Reclamation and Servicing of
Tuen Mun Area 38 for Special
Industries - Environmental
Impact Assessment Study: *Main
Report*

December 1994

EIA/024.1/94

FIGURE 2.2a - PUBLIC DUMP: SITE LAYOUT PLAN

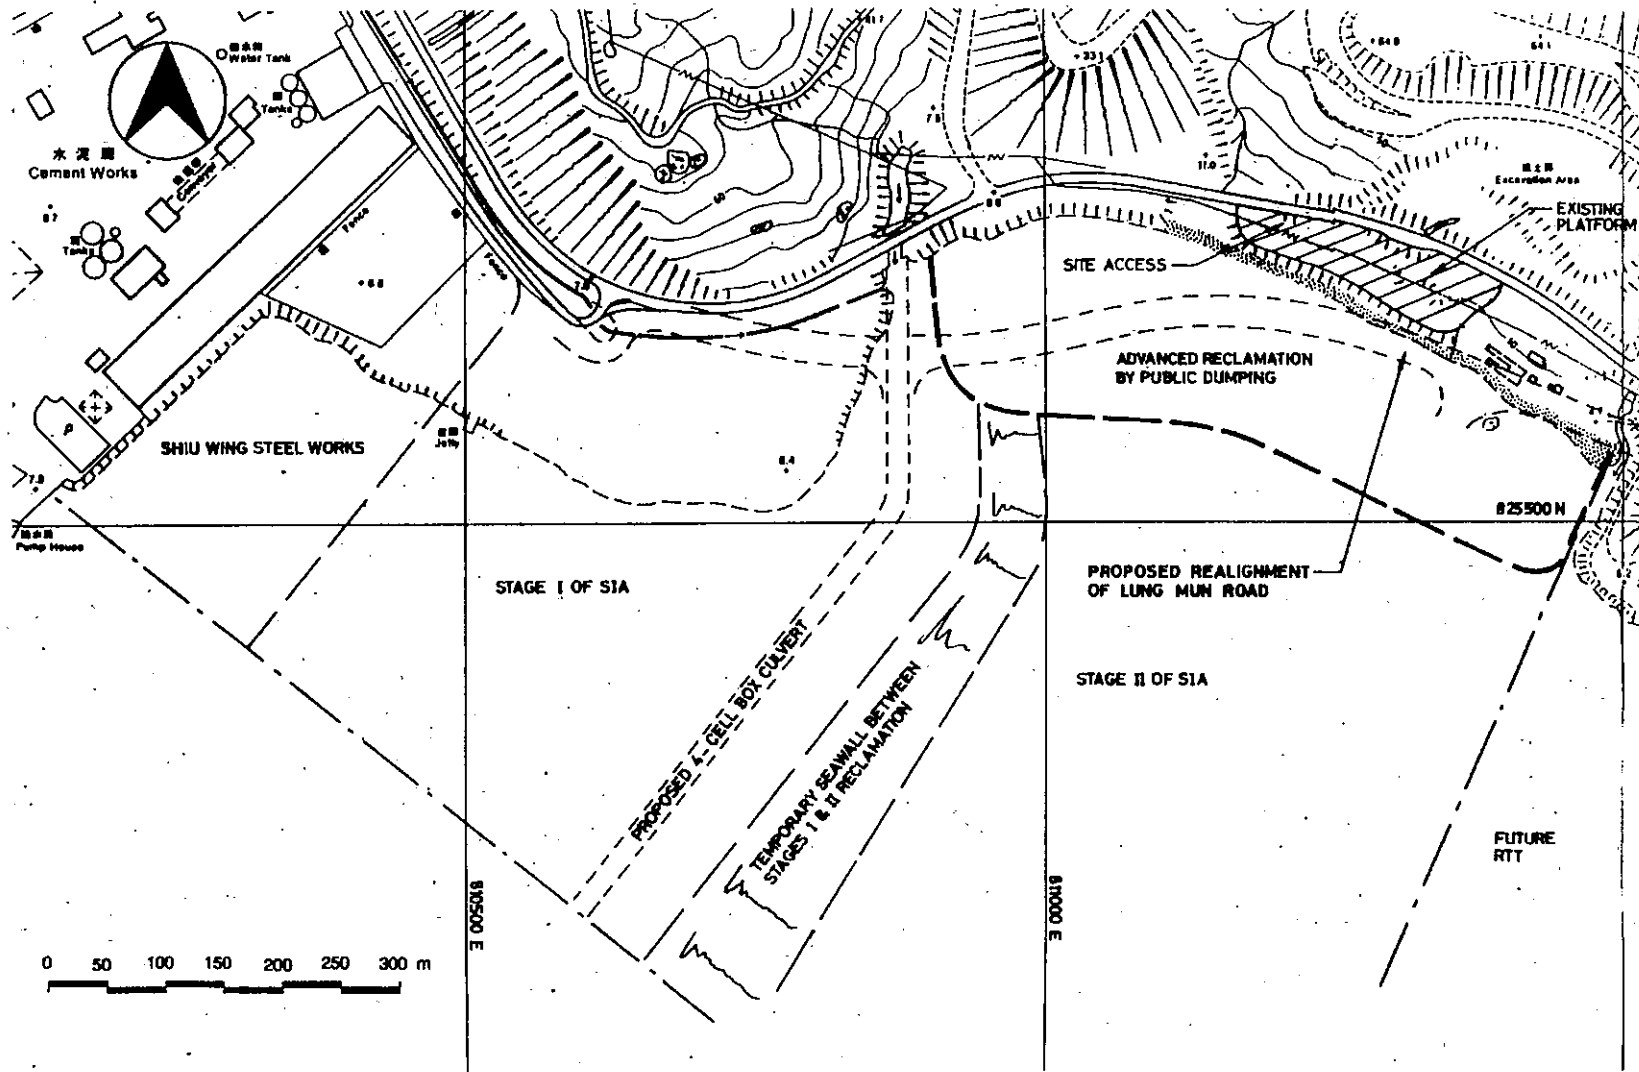
Item 2.3, page 5 Item 2.3, page 6 2nd para	The work programme shown in Figure 2.3a has been revised (see attached copy). Replace "35 ha" by "17 ha" in the 6th sentence for Stage I reclamation shown in Figure 2.2a of the Report; <i>Penultimate paragraph</i> Replace "6 months" by "6-9 months" in the first sentence; I understand that the South Cheung Chau Spoil Disposal Area is to be full. Please request the EIA Consultants to check with EPD accordingly. Volume of stockpiled material in Area 19 is revised to about 86,000 cu.m. instead of 50,000 cu.m. It is expected that the contractor will transport the excavated materials from stockpiles in Areas 16 and 19 to the CEO site and load them onto barges for deposition into the vertical seawall and box culvert foundation and for forming the temporary seawall.	Noted. The text and figure will be amended accordingly in the Final Report. Noted. Text will be amended accordingly in the Final Report. Noted. It has been confirmed with FMC (Marine Disposal) that no further spoil disposal will be allowed in the South Cheung Chau Spoil Disposal Area as the available capacity in this area has been fully allocated. The Spoil generated from Area 38 may have to be disposed of at the East Ninepins Disposal Area. Noted. Text Amended.
